Meeting: **November 1, 2021**
Project: **Hickory Meadows SD
phase 3 Final Plat**
Planner: Nathan Crouch

HICKORY MEADOWS SUBDIVISION, PHASE 3 FINAL SUBDIVISION (PUD) PLAT APPROVAL REQUEST

FINAL PLAT FOR
HICKORY MEADOWS SUBDIVISION PHASE 3
TONTITOWN, ARKANSAS

FINAL PLAT

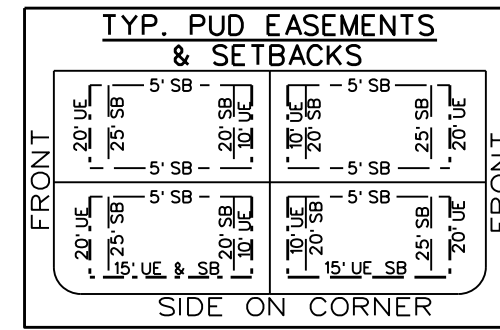
Water: Tontitown Water- There is an existing 8-inch waterline on Klenc Road. Interior waterlines are a combination of 6-inch and 8-inch lines. A final inspection of this subdivision has not yet been scheduled; any deficiencies will need to be resolved prior to signing the Final Plat. The water and sewer lines and manhole locations and other detailed information must be added to the Final Plat prior to filing.

Sewer/Septic: Sewer- this project proposes to connect to the City of Tontitown sewer system. The design has been submitted and reviewed by the City Engineer. Any outstanding comments must be addressed and noted on the plat prior to signing and filing.

The City Engineer reviewed this proposed Final Plat and noted the following drainage easement needs to be added prior to filing the Final Plat.

Additionally, during a Preliminary Site Visit on Thursday, October 27, 2021 it was noted that there appeared to be a few sediment filled and damaged drainage culverts that will need to be cleaned out, and/or repaired or replaced.

A note must be added to the Plat that no lots shall have direct access onto Klenc Road or Wildcat Blvd. The ROW for Klenc Road must be dimensioned on the Final Plat prior to filing. There has not been a final inspection done on this subdivision as of the time of this report, however, prior to filing Final Plat all streets must be inspected and all sidewalks adjacent to exterior streets (Wildcat Blvd., and Klenc Road) as well as ADA accessible ramps shall be installed per the approved Preliminary Plat plans.

1. Prior to signing Final Plat all plat revisions noted above shall be addressed, six copies of Final Plat shall be submitted for signatures.
2. Bonds shall be submitted and reviewed for approval by the City prior to final signatures and filing of the Final Plat.
3. Restrictive Covenants establishing a POA, and outlining the quality of materials, minimum square footage of homes, and other items that were negotiated and approved during the Preliminary Plat/Rezoning to PUD phase must be file marked prior to issuance of Final Plat.
4. All drainage culverts abutting this subdivision that have been damaged must be replaced or

- repaired and all sediment removed.
5. Each lot within this subdivision shall be required to plant one tree prior to issuance of a Certificate of Occupancy.
 6. No residential homes shall be constructed prior to filing the Final Plat.
 7. Individual Residential Building Permits are required for each lot prior to individual residence construction.
